CITY OF SOUTHGATE PLANNING COMMISSION AGENDA

Special Condition and Site Plan Review

ACTION REQUESTED: Special Condition/Site Plan Review

1 EXTERIOR ELEVATION - FRONT
3/8" = 1'-0"

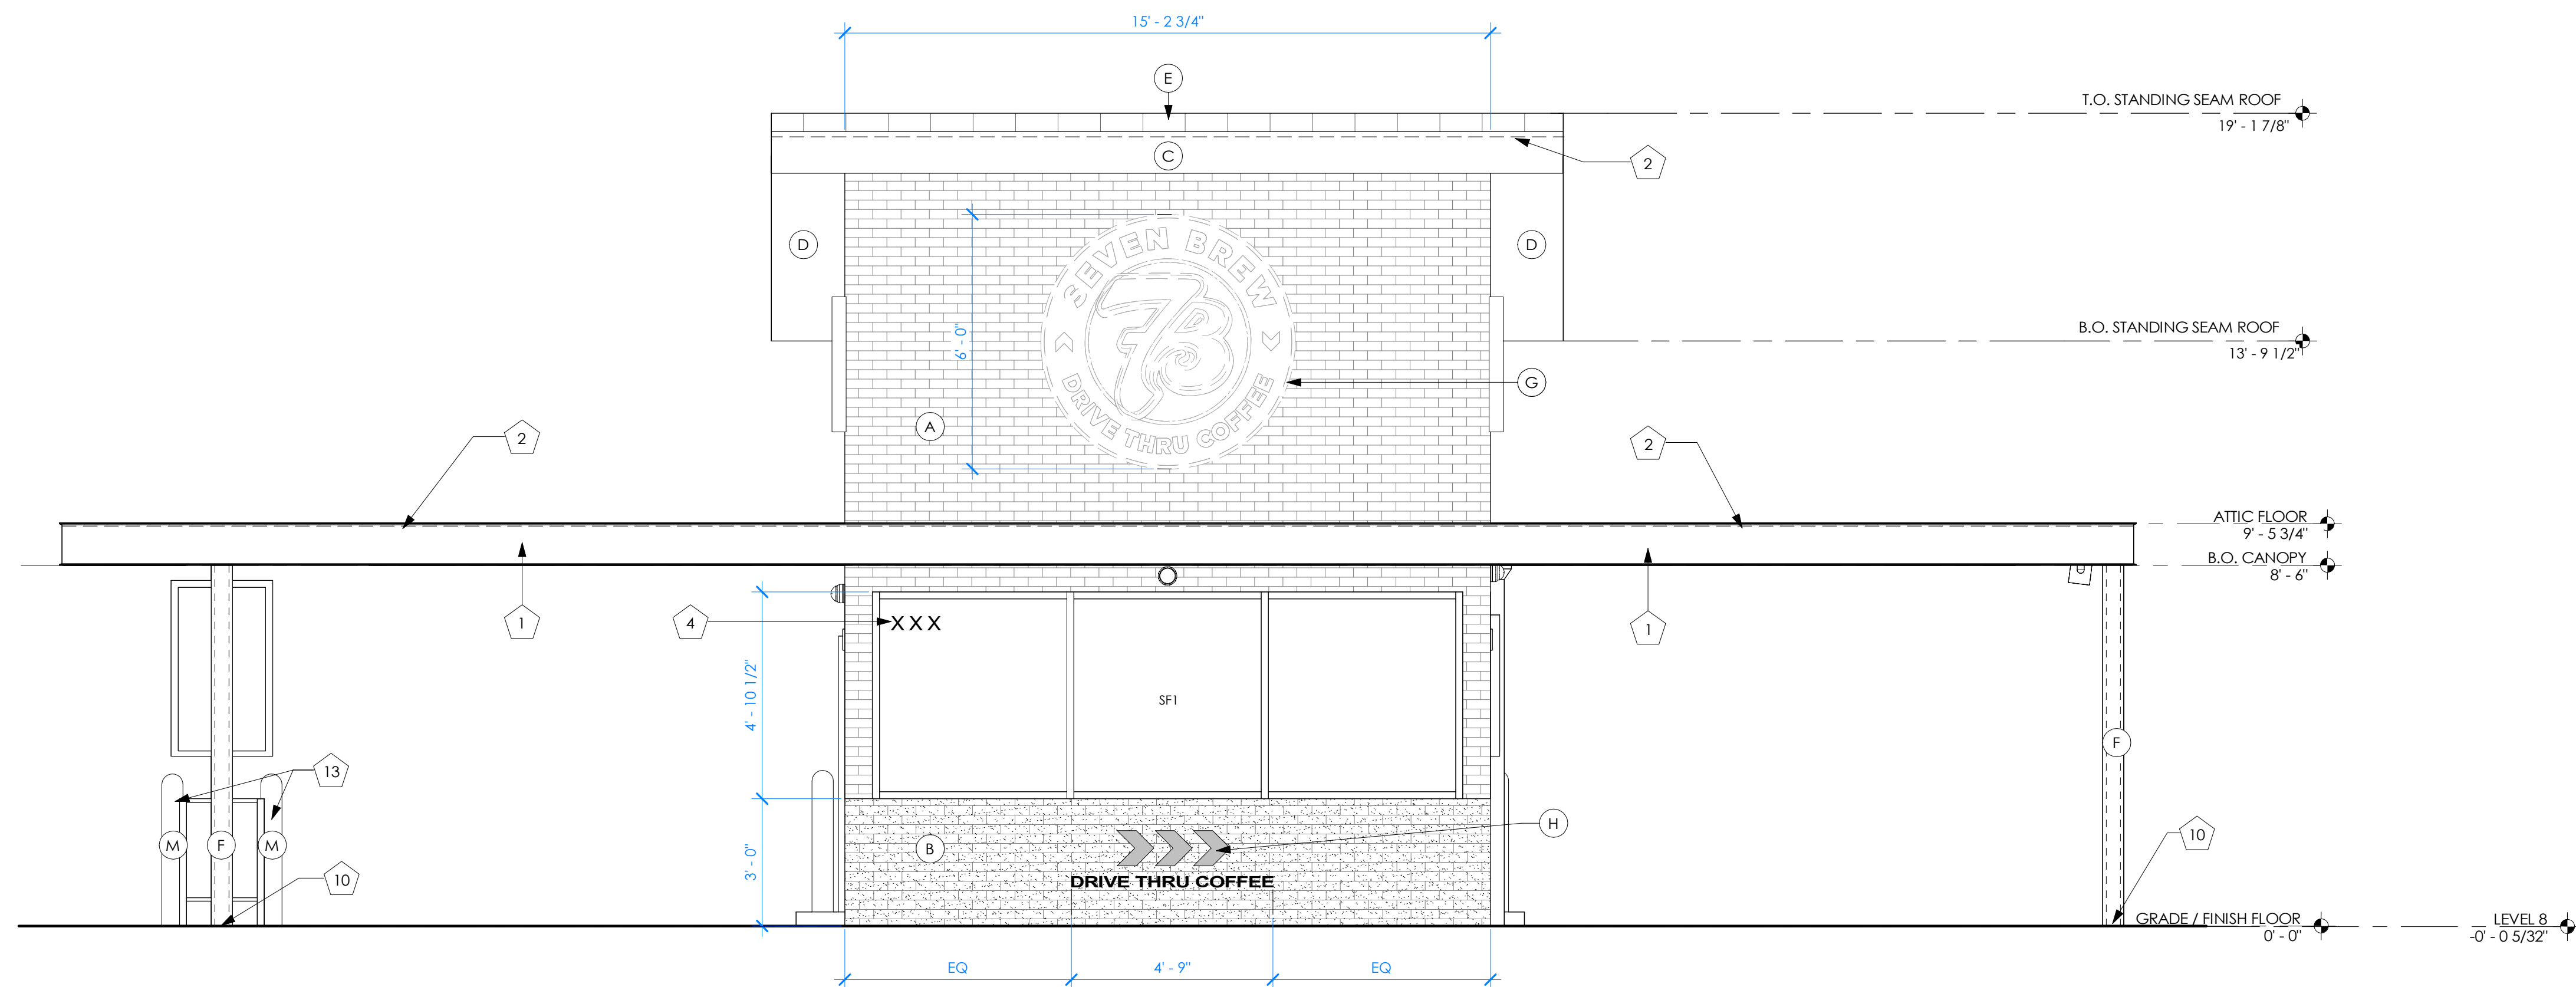
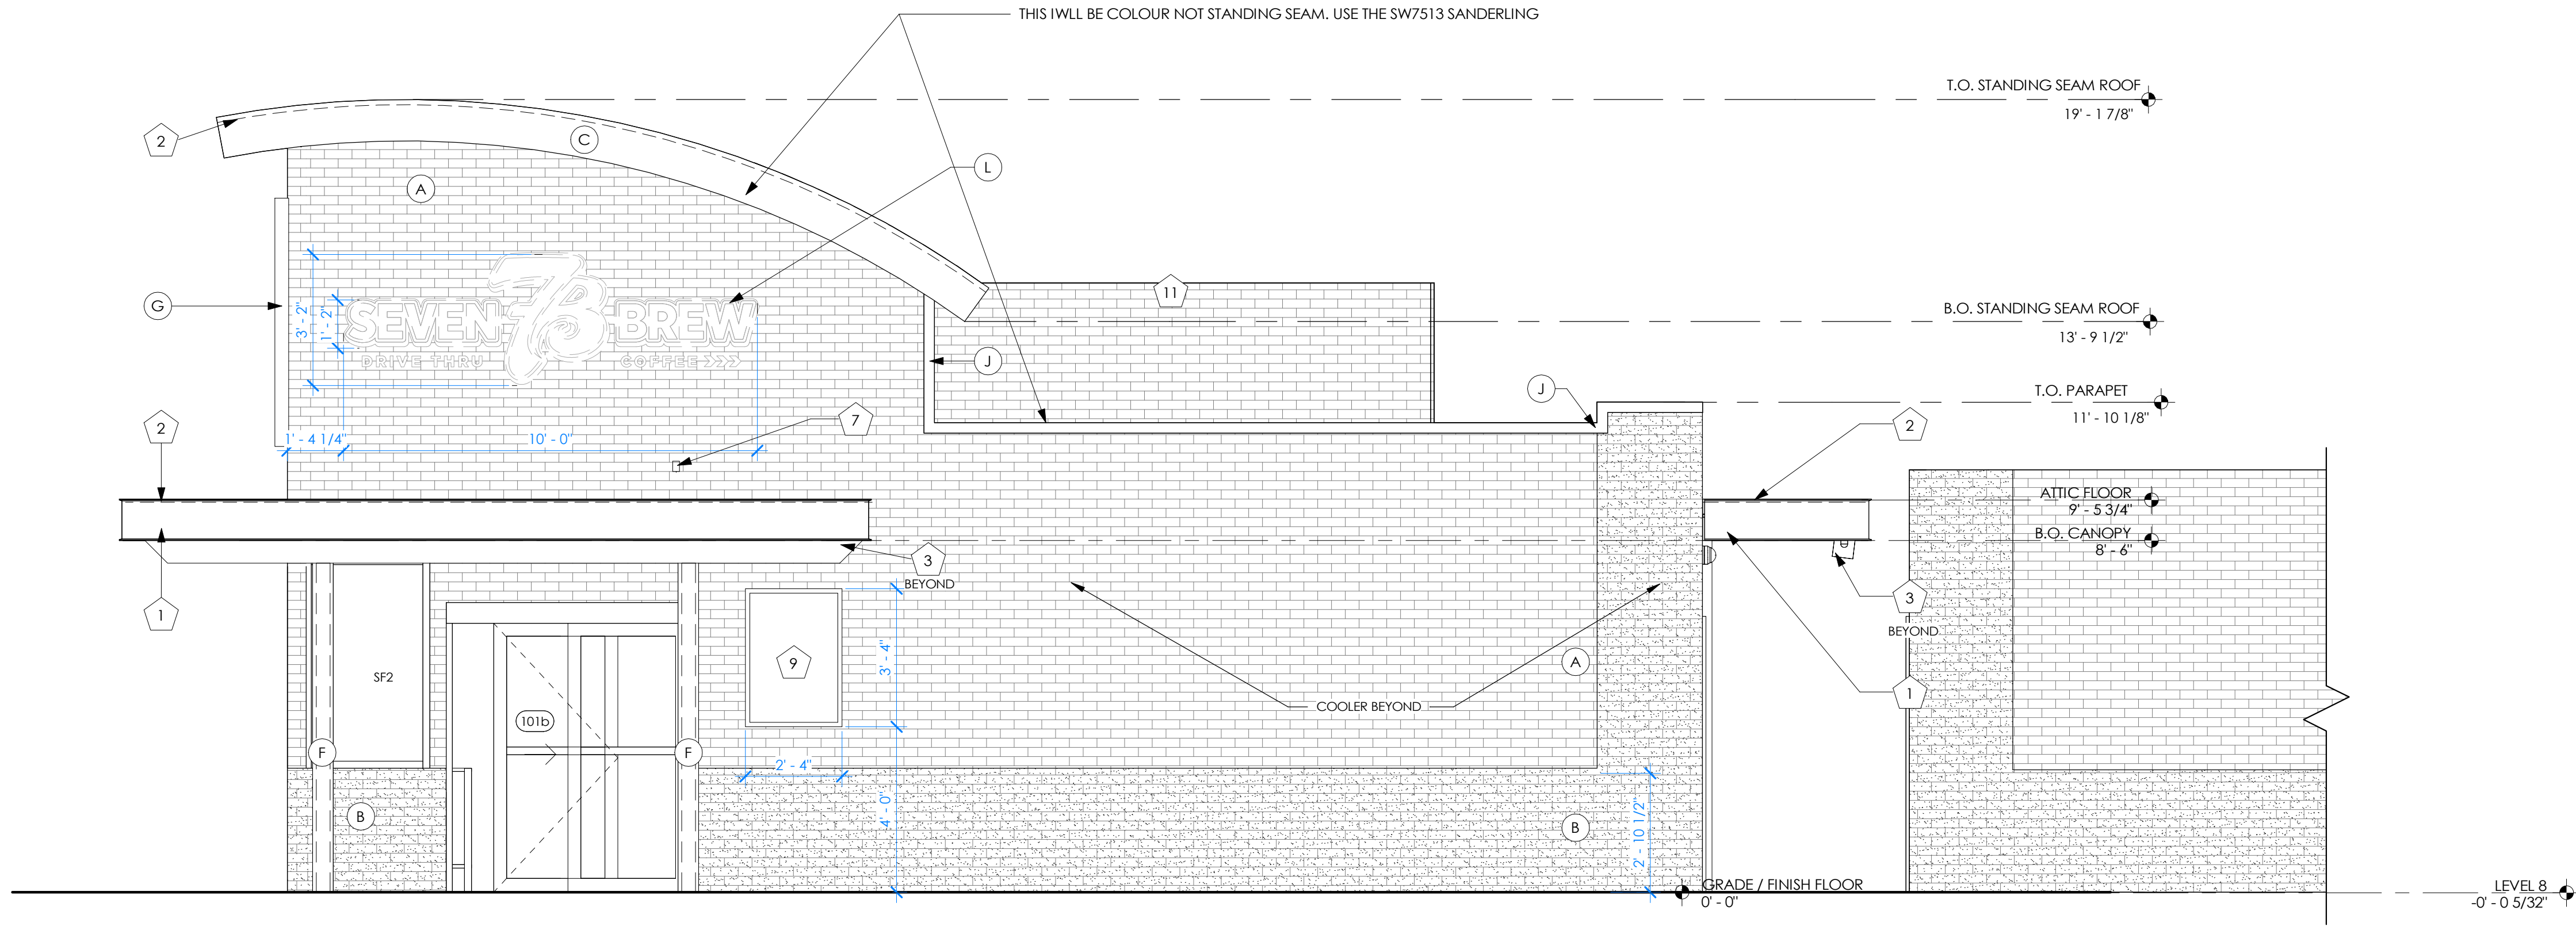
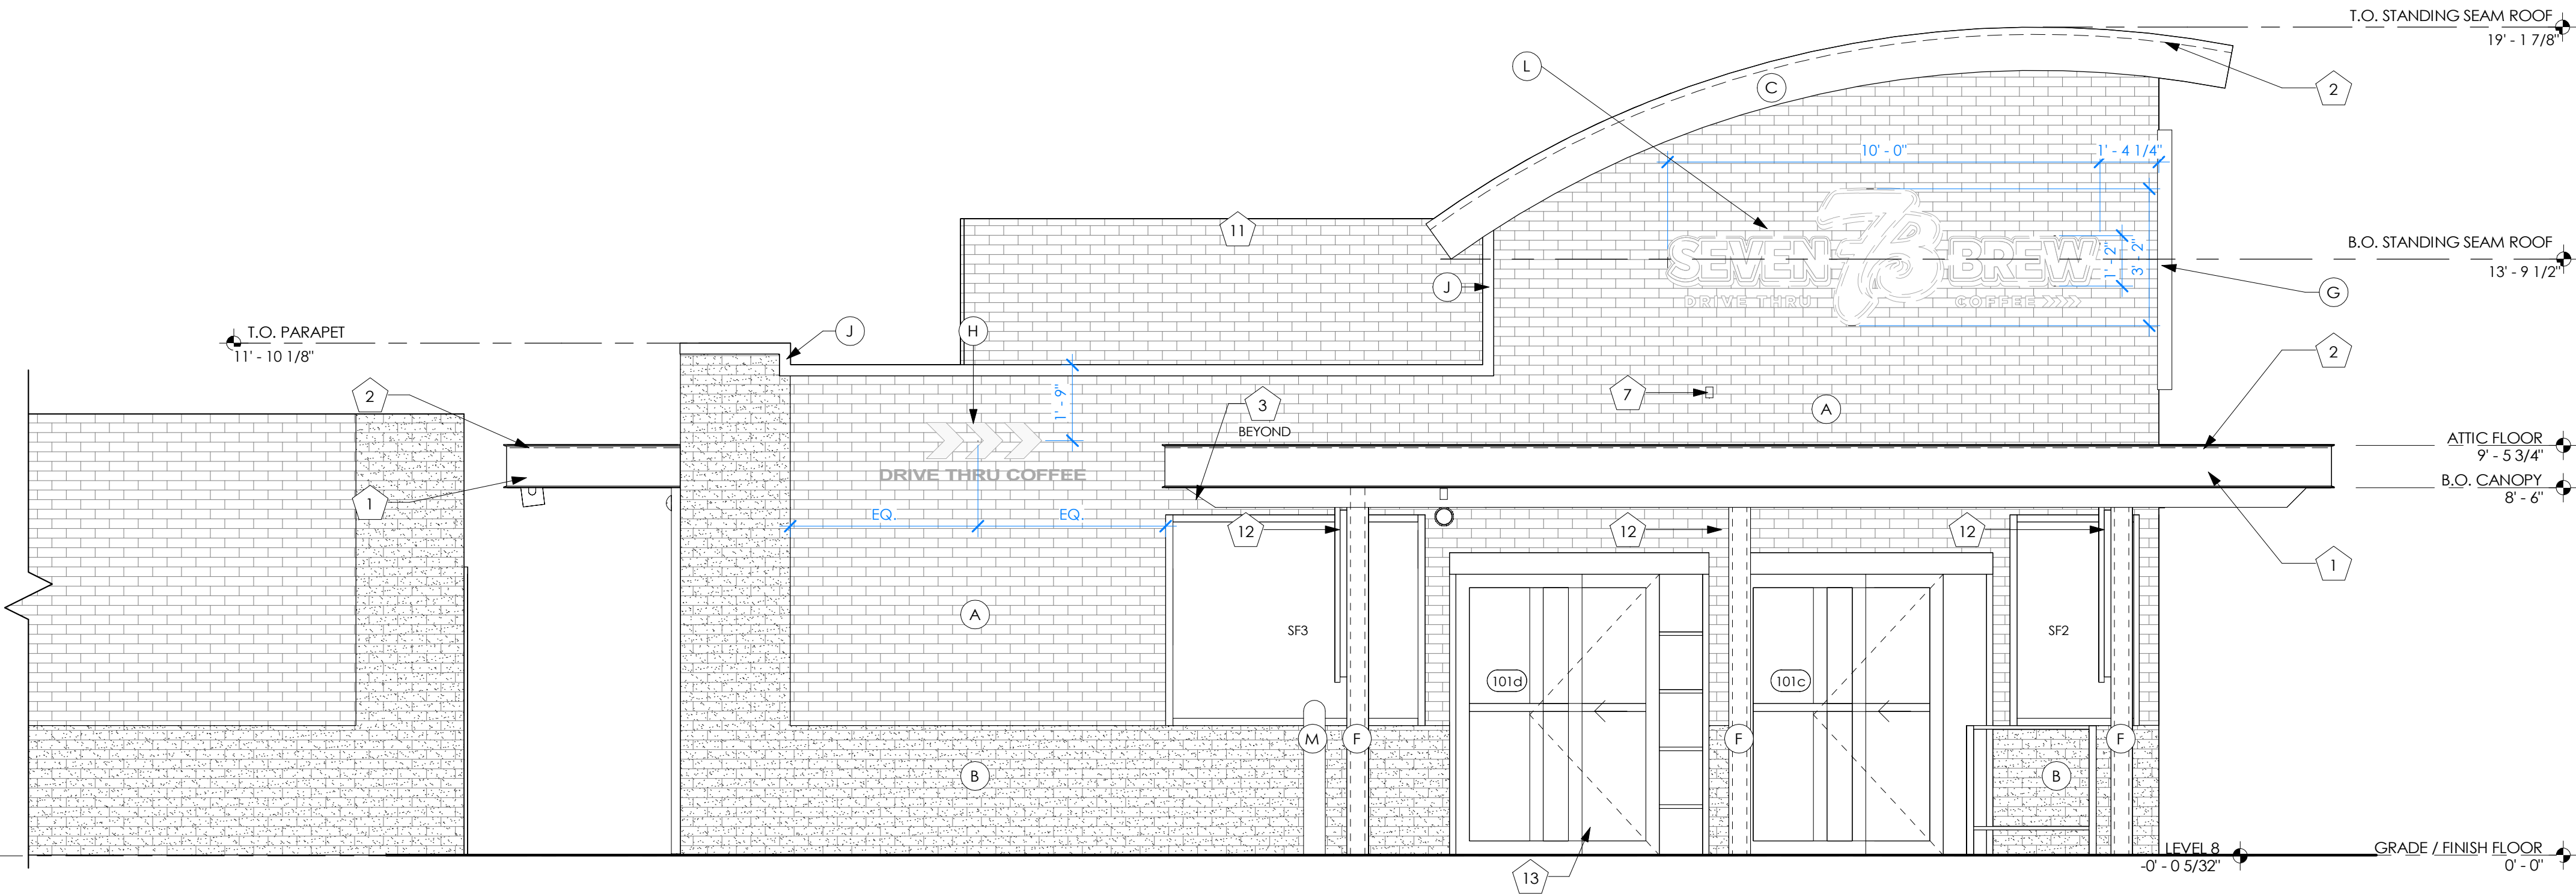
Building elevations on sheet A2.0 for the proposed coffee building shows a canopy overhang on both sides of the building (wide enough for a vehicle), where the proposed site layout on sheet C-3.0 shows almost no overhang on the eastern side of the building. We ask the applicant to provide updated elevations showing the correct canopy overhang. We defer final approval of proposed building materials to the City Building Department.

Items to be Addressed: 1) Provide updated building elevations reflecting correct canopy overhang. 2) Approval of proposed exterior building materials by the City Building Department.
